CITY OF KELOWNA

MEMORANDUM

Date: ~~September 01, 2020~~ **October 5, 2022**
File No.: Z20-0066
To: Urban Planning Management (KB)
From: Development Engineering Manager (~~JK~~) (NC)
Subject: 605 Fraser Rd and 460 Leathead Rd RU1 to ~~RM3~~ **MF2**

The Development Engineering Branch's comments and requirements regarding this application to rezone the subject lots from RU1 – Large Lot Housing to ~~RM3 – Low Density Multiple Housing~~ **MF2 – Townhouse Housing** are as follows. The Development Technician for this application will be Sarah Kelly (skelly@kelowna.ca).

SITE PLAN

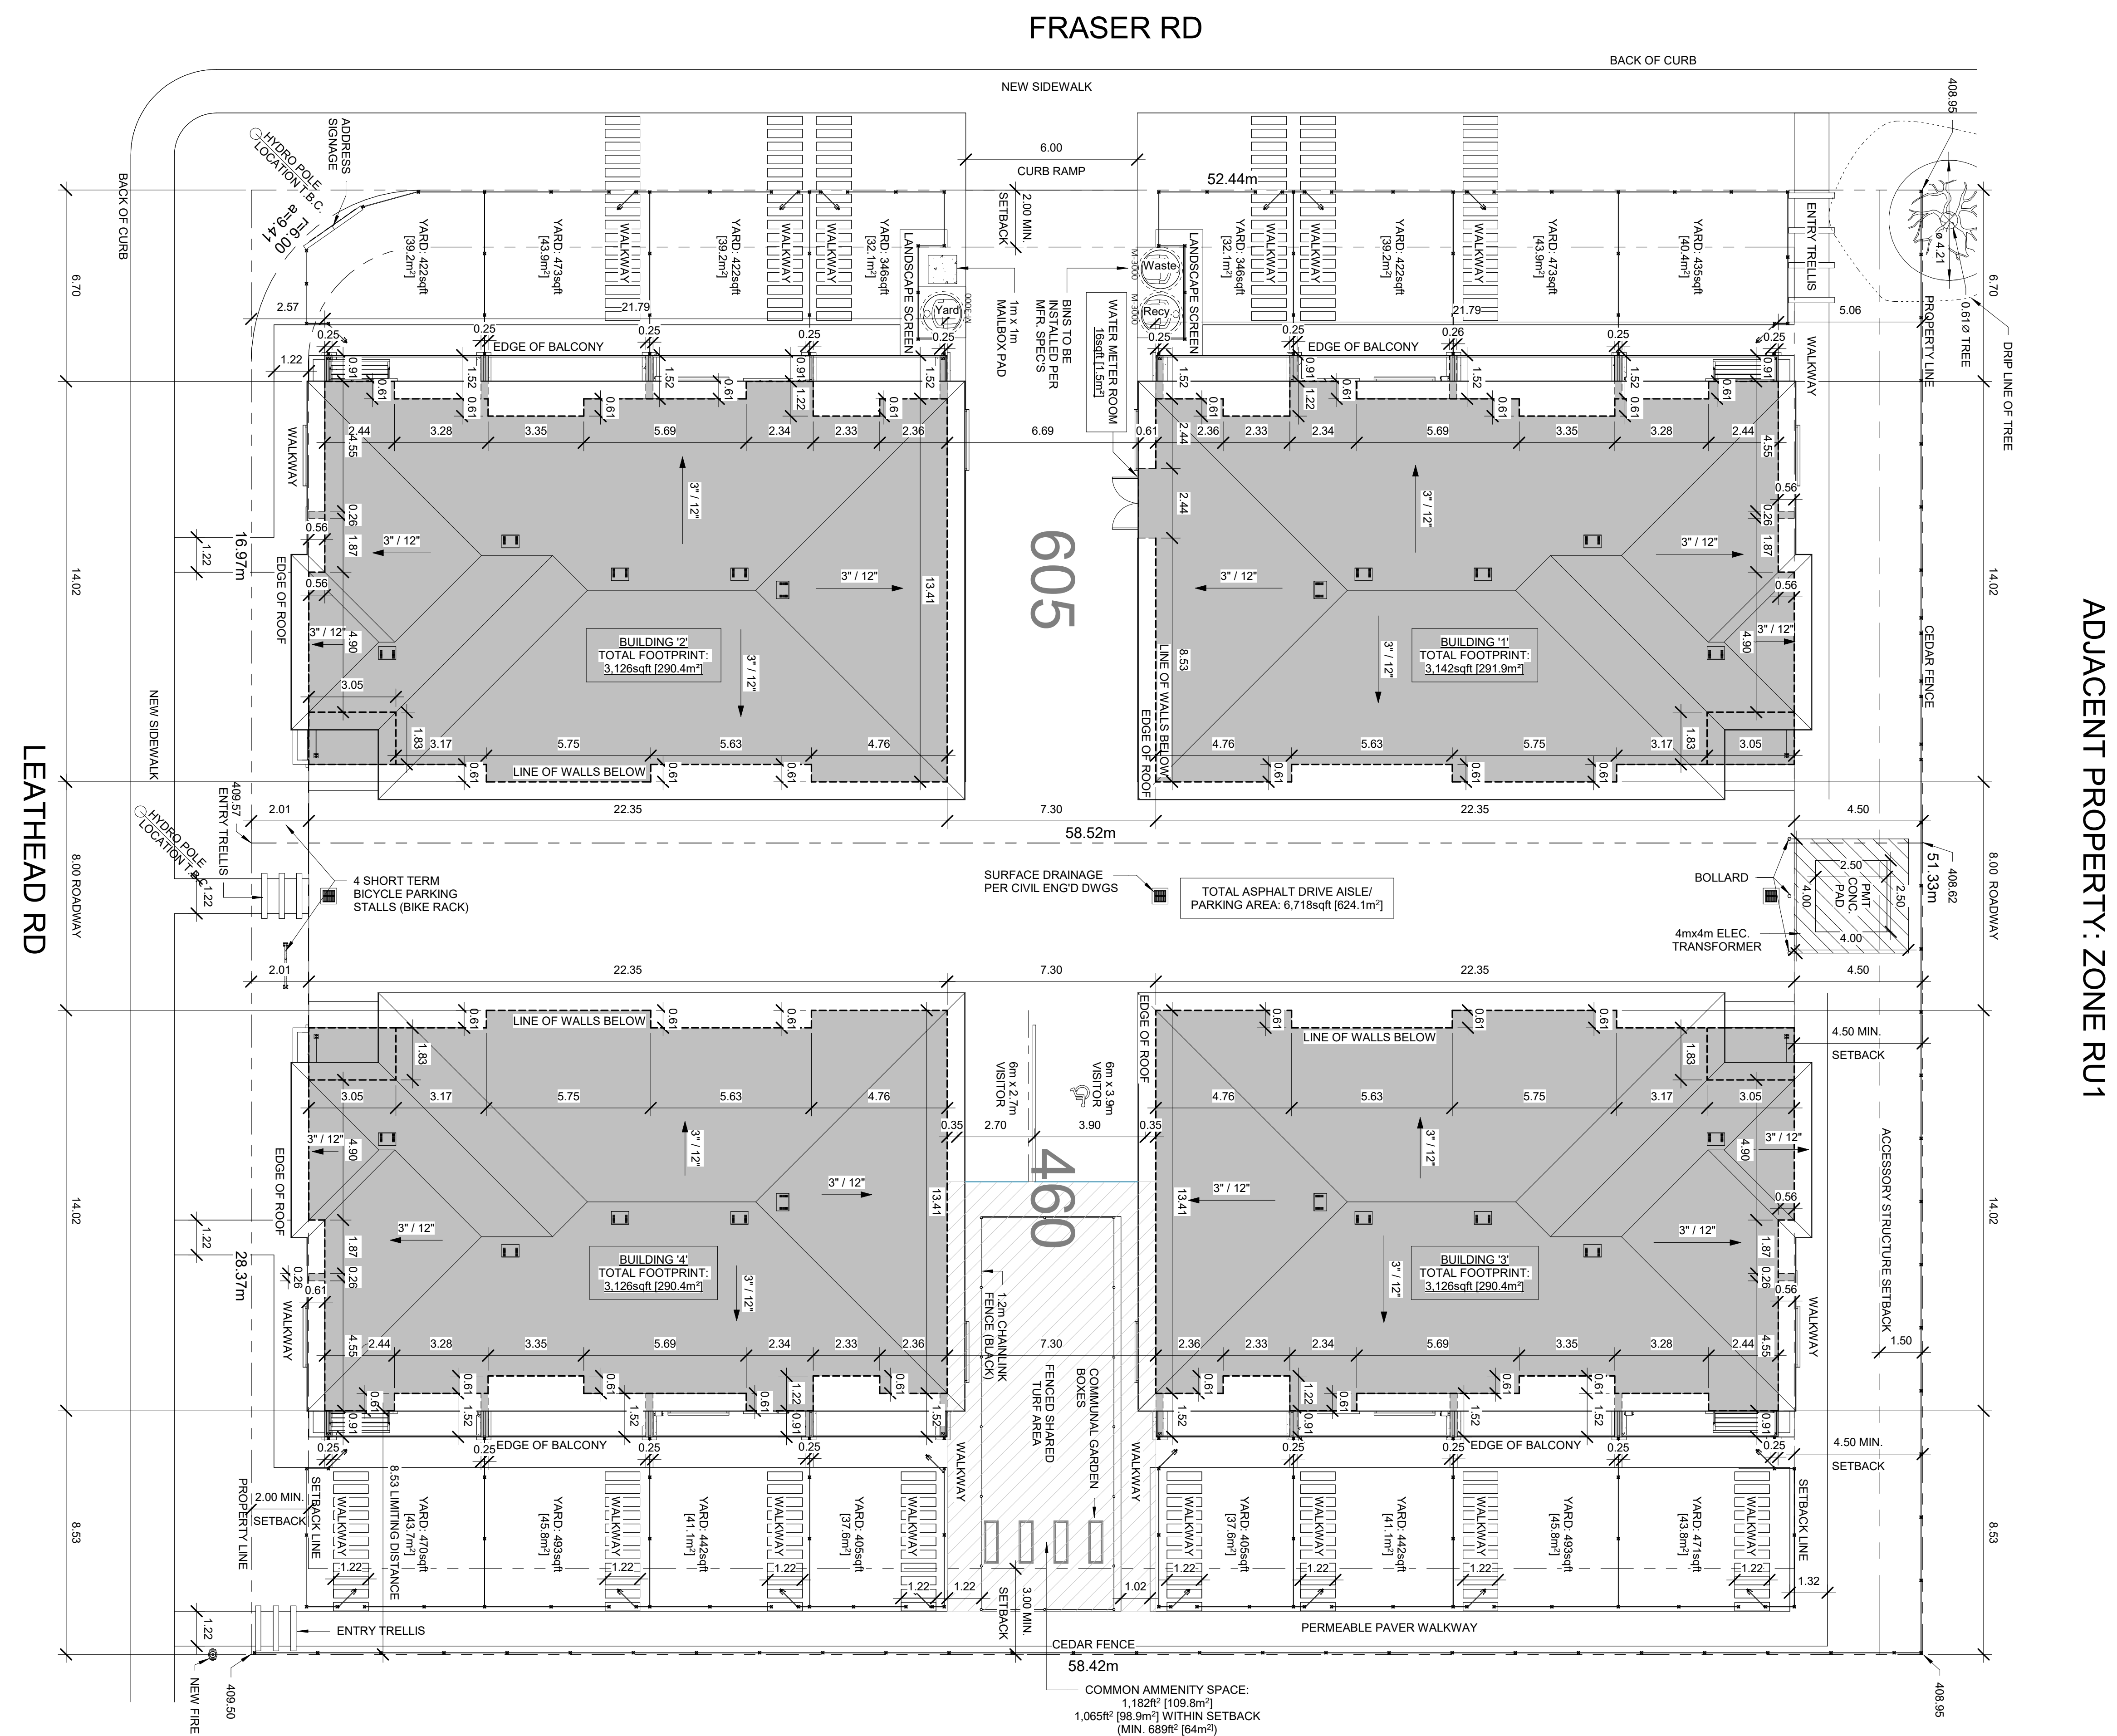
- j) A complete storm drainage system is to be installed up to north end of the subject lot within Fraser Rd, c/w catch basins, leads, storm main, manholes, any required service connections, and connection to the existing storm main in Leathead Rd. Depending on the proposed design, a latecomer may be able to be registered for the drainage works.

- a) The existing condition of the Active Transportation Corridor on Leathead Rd is to be maintained.
- b) A new east-west concrete wheelchair letdown as per City of Vancouver Standard Detail C8.3 is to be installed on the northeast corner of the Fraser-Leathead Rd intersection.
- c) The existing utility pole servicing 460 Leathead Rd is to be removed, with all new additional services being underground.
- d) Fraser Rd is to be fully urbanized to a modified SS-R5 with 1.5-m wide separated sidewalk 0.2 m from property line. The urbanization is to include storm drainage, curb and gutter, utility appurtenance adjustments, fillet paving, streetlights, boulevard landscaping and irrigation, and utility pole relocation (if necessary).

- a) A 6.0-m radius corner rounding is to be dedicated on the southwest corner of 605 Fraser Rd.
- b) Lot consolidation will be a requirement of this development.
